THE NATIONAL CONSTRUCTION CODE VOLUME ONE

**WESTMEAD HOSPITAL
ADDITIONAL REFURBISHMENT WORKS
OPERATING THEATRES 9 - 16**

**Health
Infrastructure**

Revision 0
Date: 02 June 2023
Reference: 220438

Figure No. 1 – Proposed fire and smoke compartment (G3.3) housing Operating Theatres 11 – 16 and part of the Stage 1 refurbishment

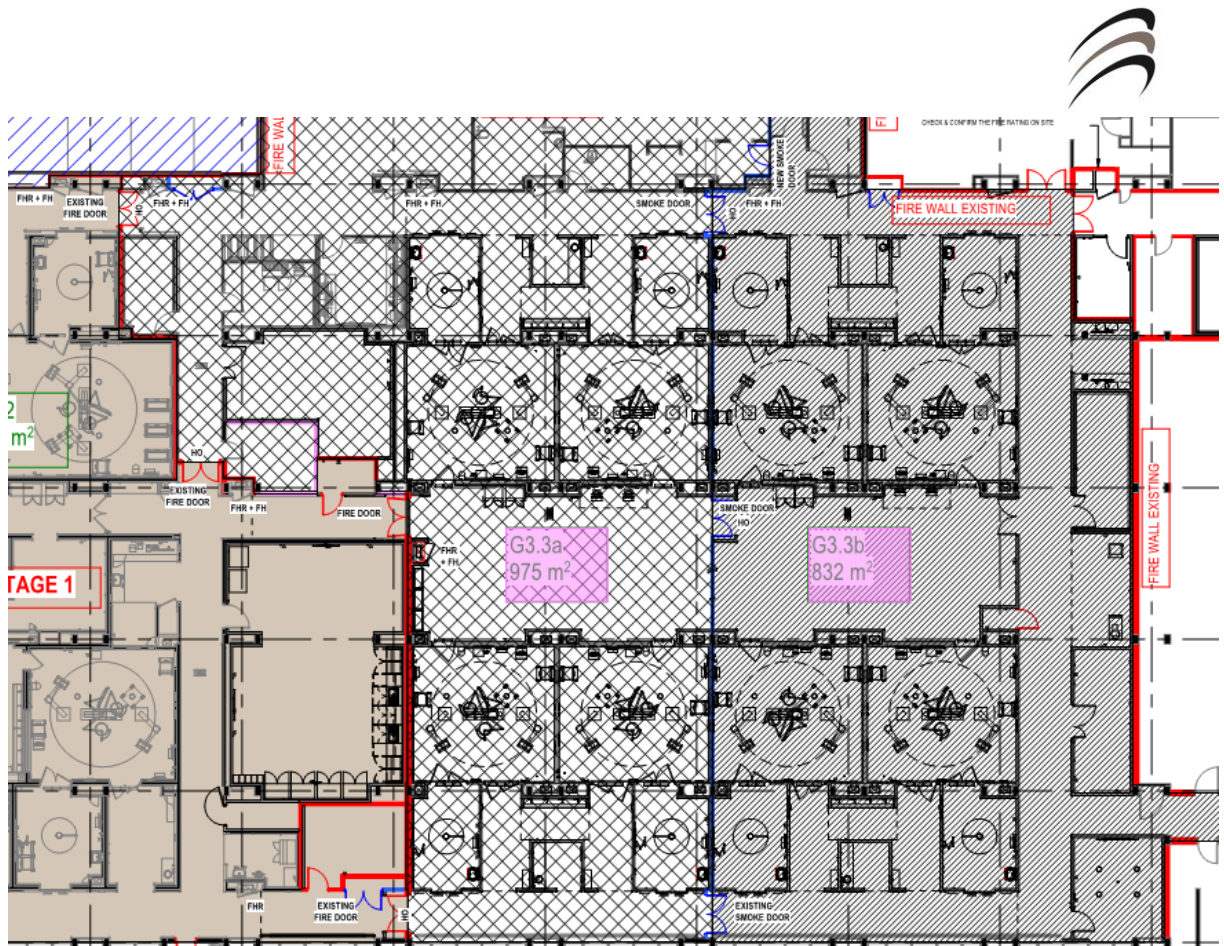
Having regard to a review of the proposed Compartmentation Drawings, it is noted that the total Fire Compartment size of G3.3 is less than 2,000 m² (1,807 m²) and Smoke Compartments G3.3a and G3.3b do not exceed 1,000 m² (975 m² and 832 m²). In this instance compliance with Clause C3D6 is achieved.

Figure No. 3 – Locations of extended travel distance to a point of choice within the Level 3 OTs and Roof Top Plant Room

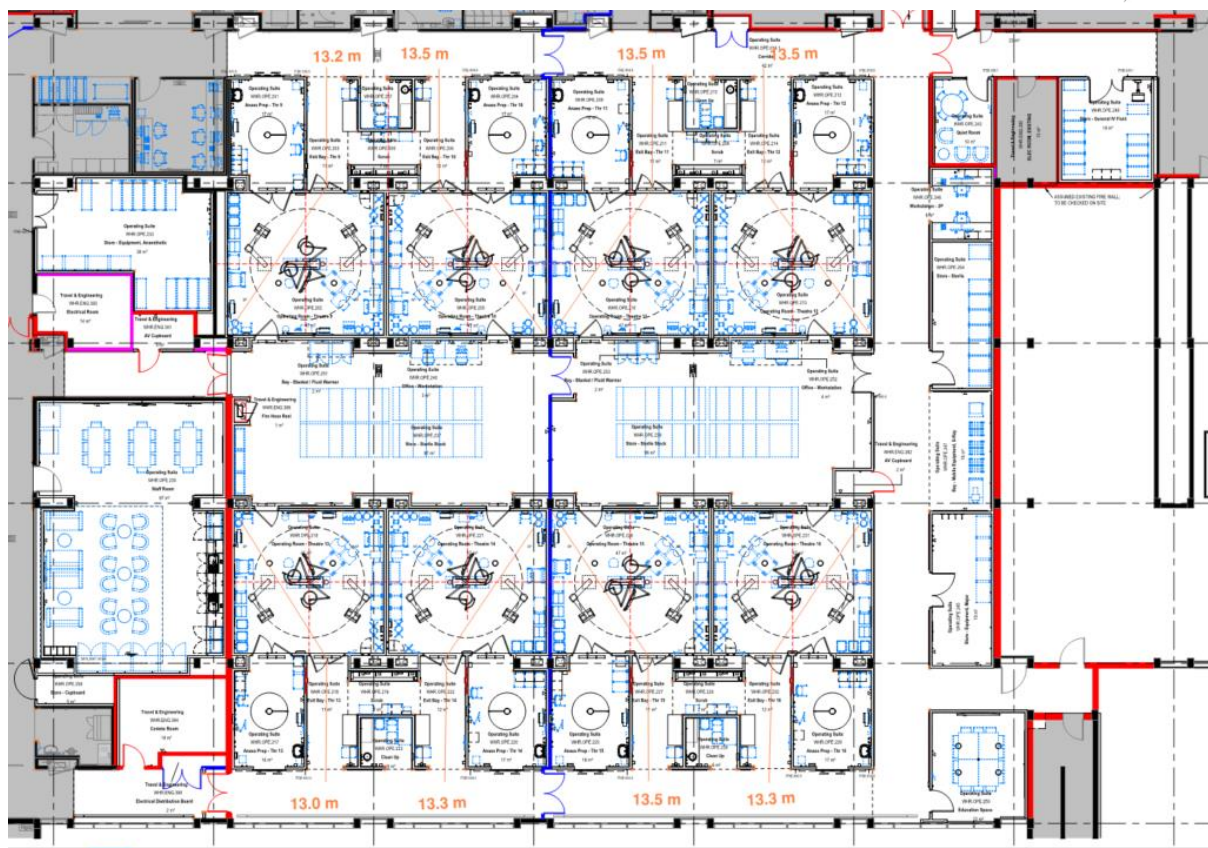
Based on the Schematic Design Issue Architectural Drawings assessed to date, we have undertaken an egress assessment in terms of egress travel distance to an exit and based on our review, we provide the following comments:

- + Travel distance to a point of choice from the individual Operating Theatres exceeds 12m with the most excessive travel distance being up to 13.5 m (1.5 m over the maximum distance permitted by DTS).

The extended travel distance to a point of choice and to an alternative exit from the subject Operating Theatres will be required to be assessed as part of a Fire Engineering Assessment to be undertaken by Arup in order to demonstrate compliance with the nominated Performance Requirements of the BCA.

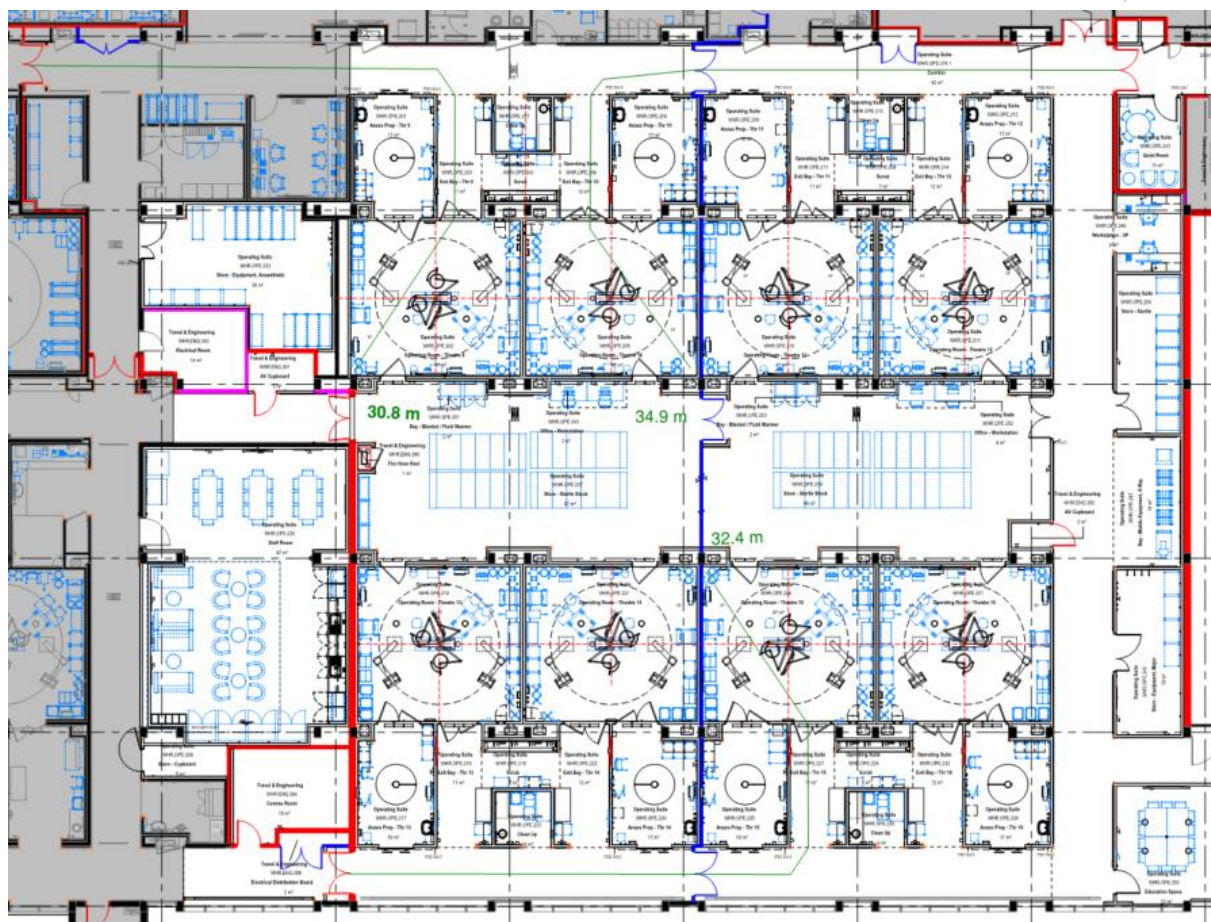
- + Travel distance from a number of the Operating Theatres to the nearest alternative exit exceeds 30 m, with the most excessive travel distance being up to 35 m (5 m over the maximum distance permitted by DTS).

Figure No. 7 – Location of sliding doors within the proposed Operating Theatres 9 - 16

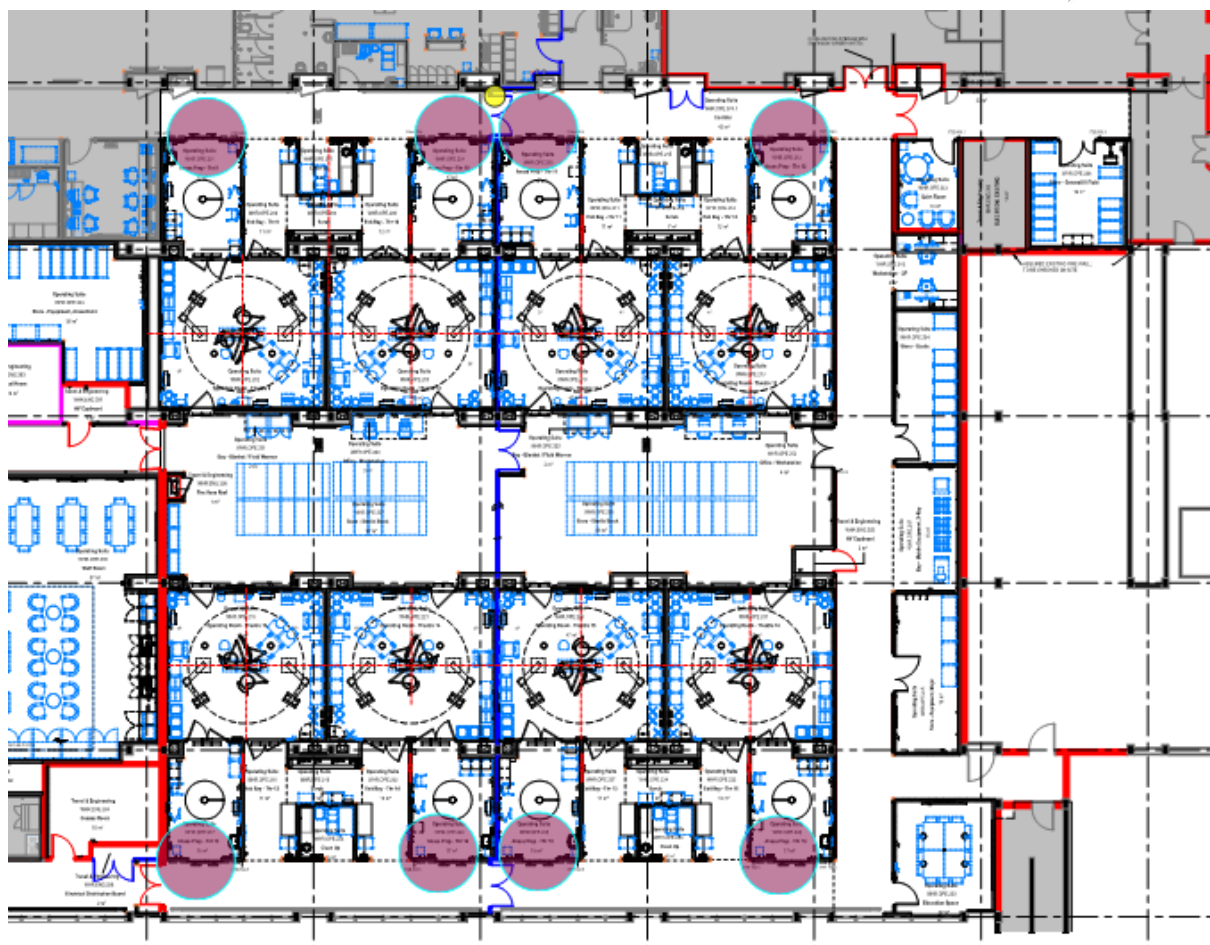
It is noted that there are a number of sliding doors which are located at the entry to the Anaesthetic Preparation Rooms associated with the Operating Theatres.

The provision of the sliding doors will be required to be assessed as part of a Fire Engineering Performance Assessment to be undertaken by Arup in order to demonstrate compliance with the nominated Performance Requirements of the BCA.

Figure No. 8 – Horizontal exit doors that are required to swing in both directions

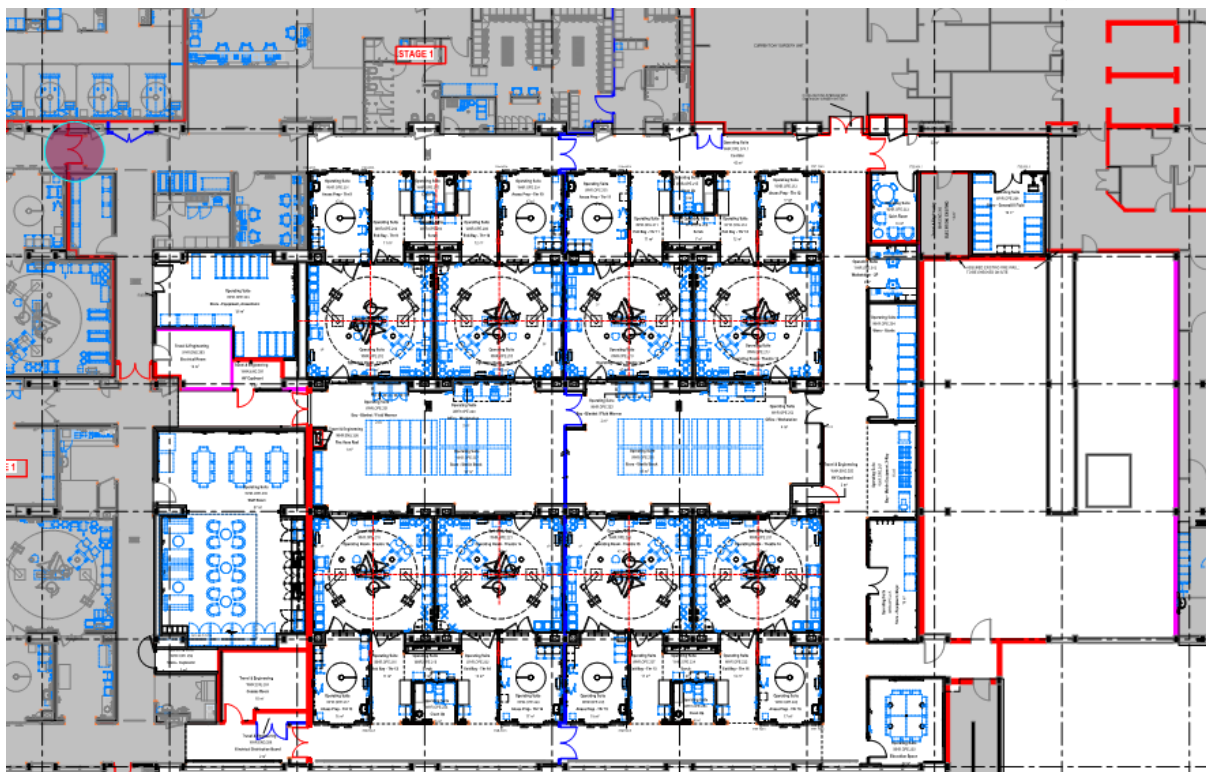
All exit doors are required to swing in the direction of egress.

As detailed under Specification 12, there are a number of fire safety doors / horizontal exits that do not swing in the direction of egress (as detailed in the Figure below).

The swing of the horizontal exit doors against the direction of egress will be required to be assessed as part of a Fire Engineering Assessment to be undertaken by Arup in order to demonstrate compliance with the nominated Performance Requirements of the BCA.

Figure No. 10– Indicative exit sign locations throughout the refurbished Level 3 area

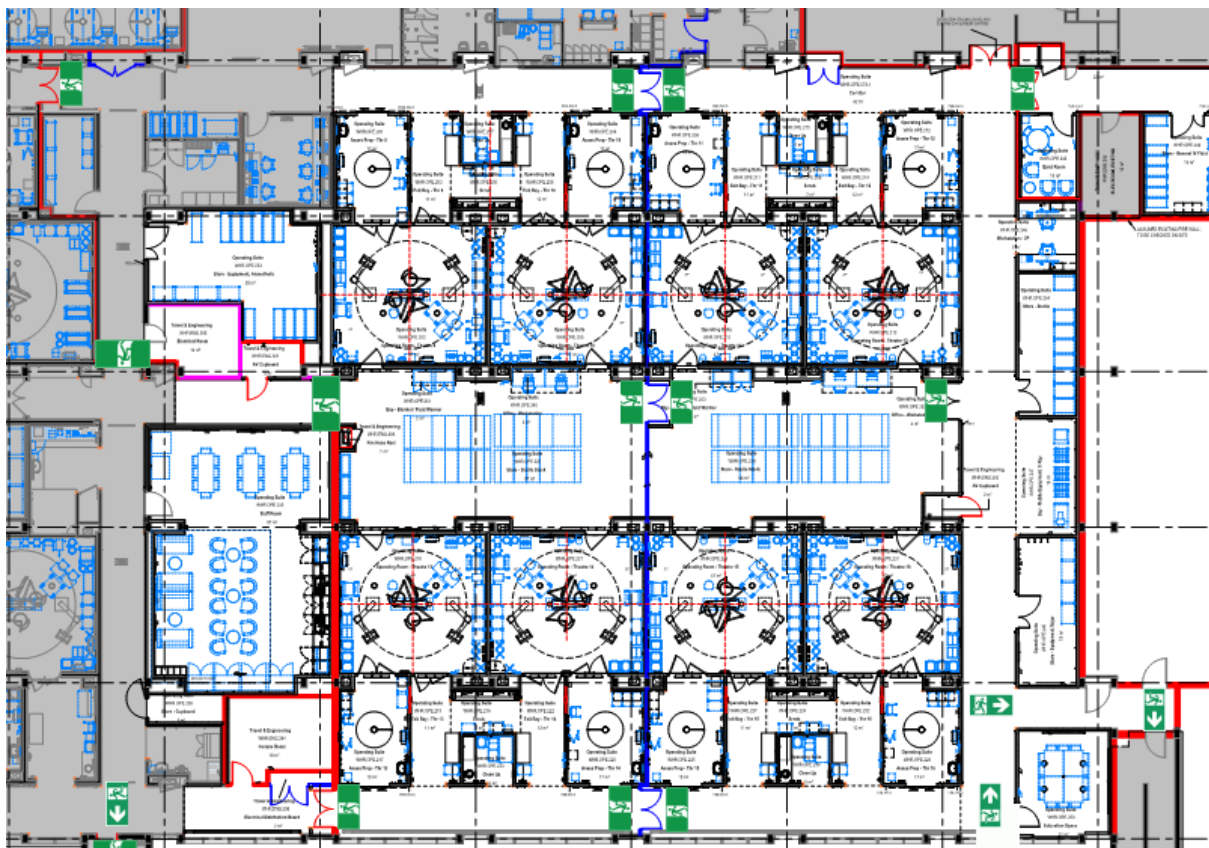
- + Doors providing direct egress from a storey to a fire isolated stairway or passageway;
- + Horizontal exit doors;
- + Fire Safety Doors (i.e., fire/smoke doors) separating compartments;
- + Doors leading from balcony areas, courtyards etc. back into the building; and
- + Above doorways in a path of travel where the location of the exit is not clear.

The following figures detail indicative exit sign locations throughout the refurbishment area.
